APPLICATION FOR OSHPD PREAPPROVAL OF
MANUFACTURER'S CERTIFICATION (OPM)

OFFICE USE ONLY
APPLICATION #: OPM-0062-13

SEISMIC SWAY BRACING FOR  
FIRE SPRINKLER SYSTEMS

ADDENDUM #1 - SUMMARY

SHEET TITLE: TRANSVERSE SEISMIC BRACE  
CSBEZU WITH BRACE PIPE FOR 1"Ø TO 6"Ø SERVICE PIPE CONNECTION

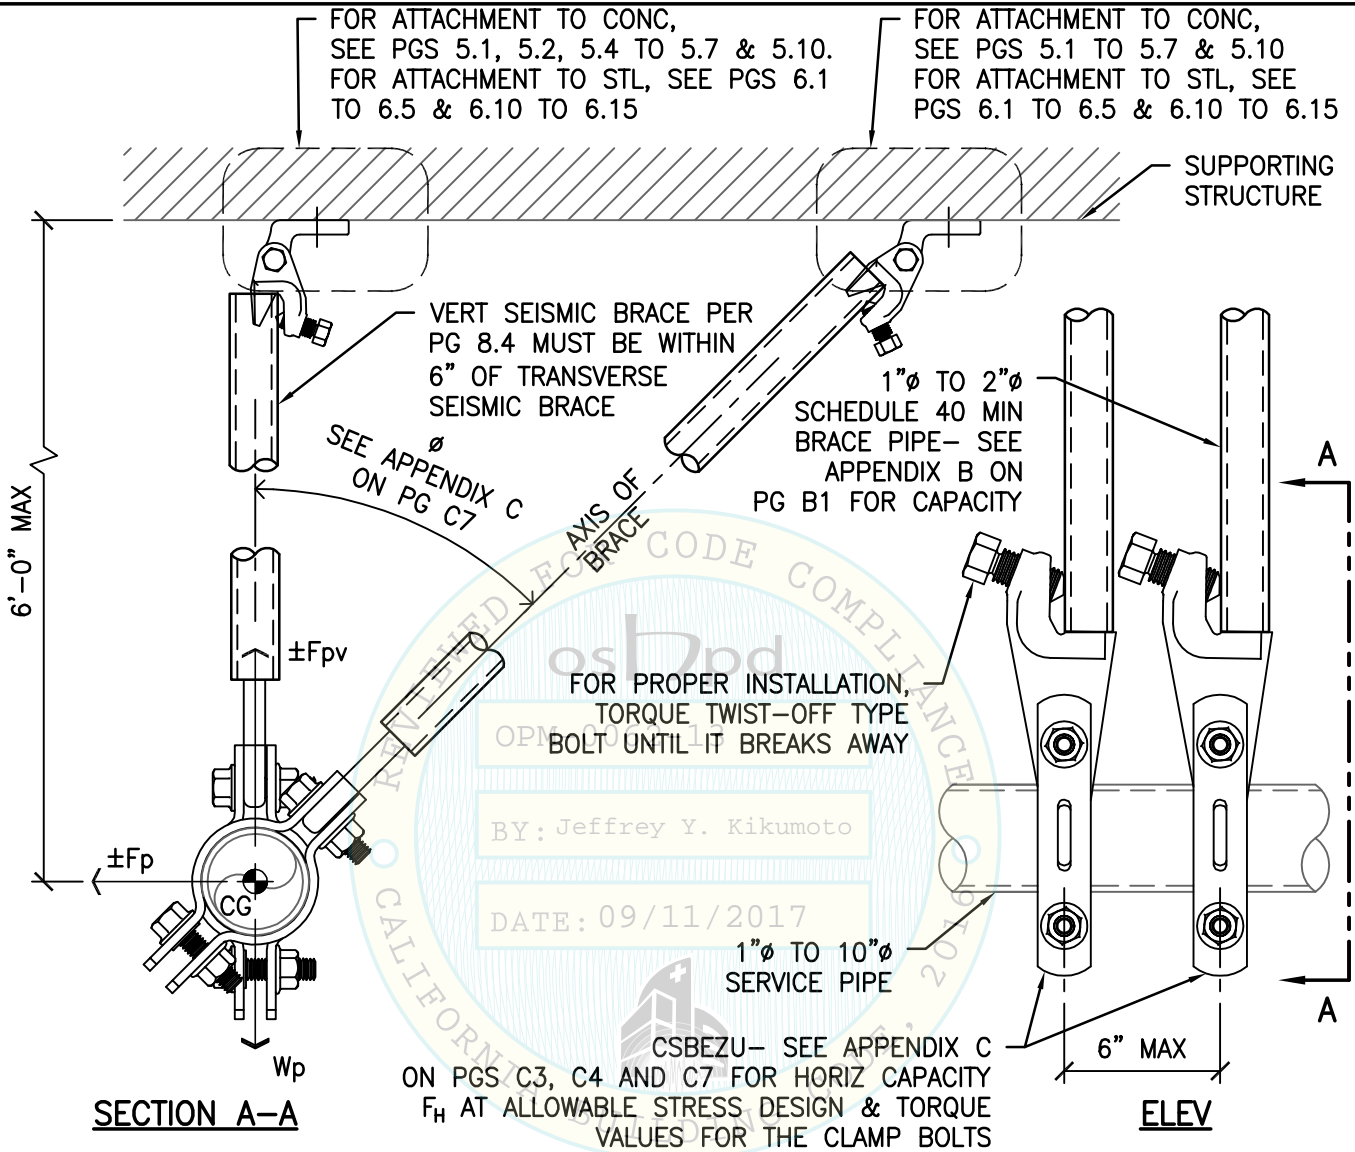
THIS IS A PHASED OUT PRODUCT AND MAY STILL BE USED. FOR CORRESPONDING REPLACEMENT, SEE PG 2.6.

SHEET TITLE: LONGITUDINAL SEISMIC BRACE  
CSB WITH BRACE PIPE FOR 1"Ø TO 10"Ø SERVICE PIPE CONNECTION

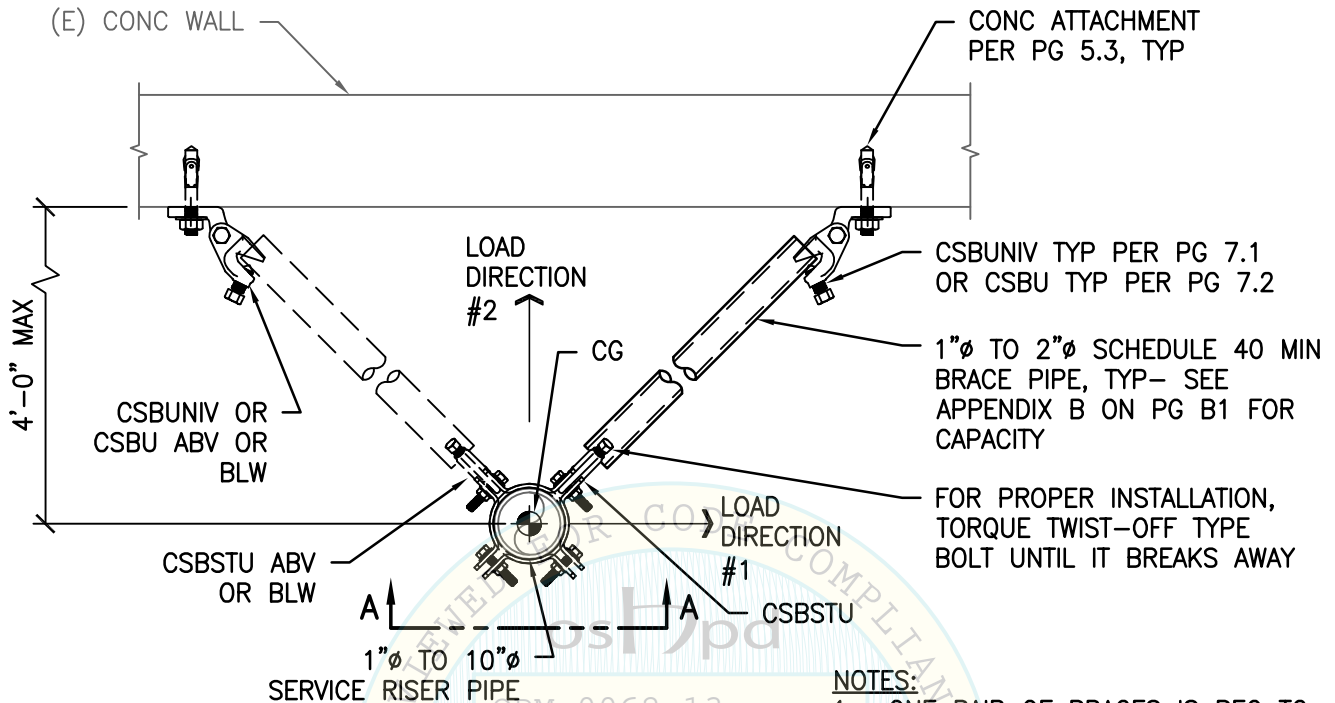
**THIS IS A NEW PRODUCT**
